UNITED STATES
NUCLEAR REGULATORY COMMISSION
WASHINGTON, D. C. 20555

Docket Nos. 50-245
and 50-336

The Commission has issued the enclosed Amendment No. 75 to Provisional Operating License No. DPR-21 and Amendment No. 65 to Facility Operating License No. DPR-65 for the Millstone Nuclear Power Station, Unit Nos. 1 and 2. The amendments are in response to your application dated February 3, 1978, as supplemented February 2, 1979, and application dated July 2, 1979, as supplemented July 3, 1980.

The amendments approve changes to the Appendix B (Environmental) Technical Specifications (ETS) which delete surveillance requirements specified in 3.1.2.1.1 Exposure Panels, 4.6 Thermal Plume Study, and 4.7 Chlorination. The amendments also approve several changes involving the following aquatic monitoring programs: Benthic Survey, Trawling, Entrainment Studies, and Impingement Monitoring.

Figure 3.1.2 Location of Trawl Sampling Stations

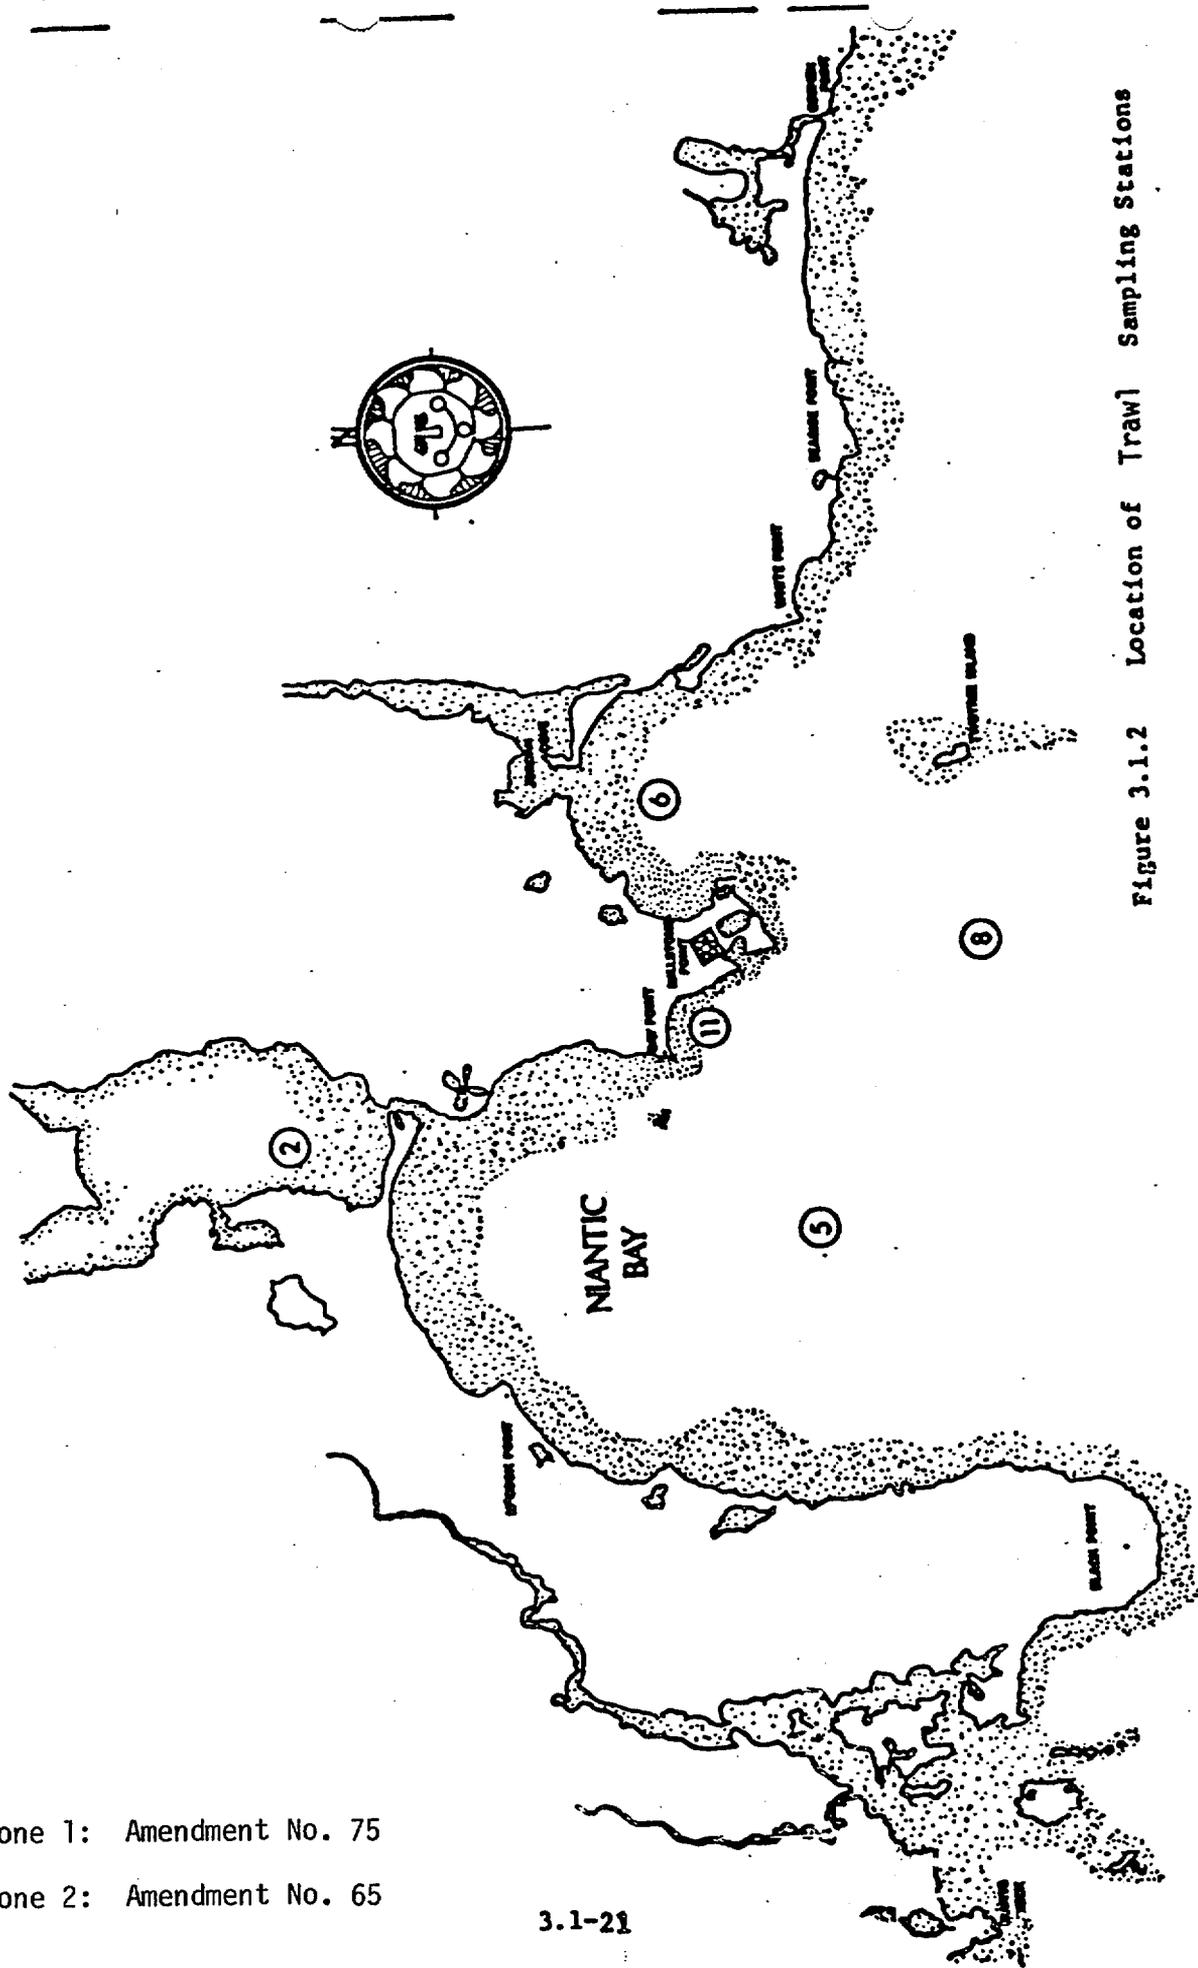
You requested three changes dealing with (1) the removal of extraneous sampling stations indicated in Figure 3.1.2; (2) deletion of the requirement to calculate the condition factor of captured organisms; and (3) deletion of the requirement to record information on reproductive activity of captured organisms.

- (1) Figure 3.1.2 is no longer applicable to the Plankton Program since the study requirements have been satisfied and the study previously deleted from the ETS. The figure is still applicable to the trawl program and has been updated to include only those stations. Therefore, we find the proposed change acceptable.

A 30-foot otter trawl with 1/4 inch cod-end liner shall be used to trawl six locations around Millstone Point every other week. (Stations 2, 5, 6, 8, 11, 14 (Fig. 3.1-2). Fish and selected invertebrates collected shall be identified and representative numbers will be measured. Efforts will be made to release uninjured individuals alive.
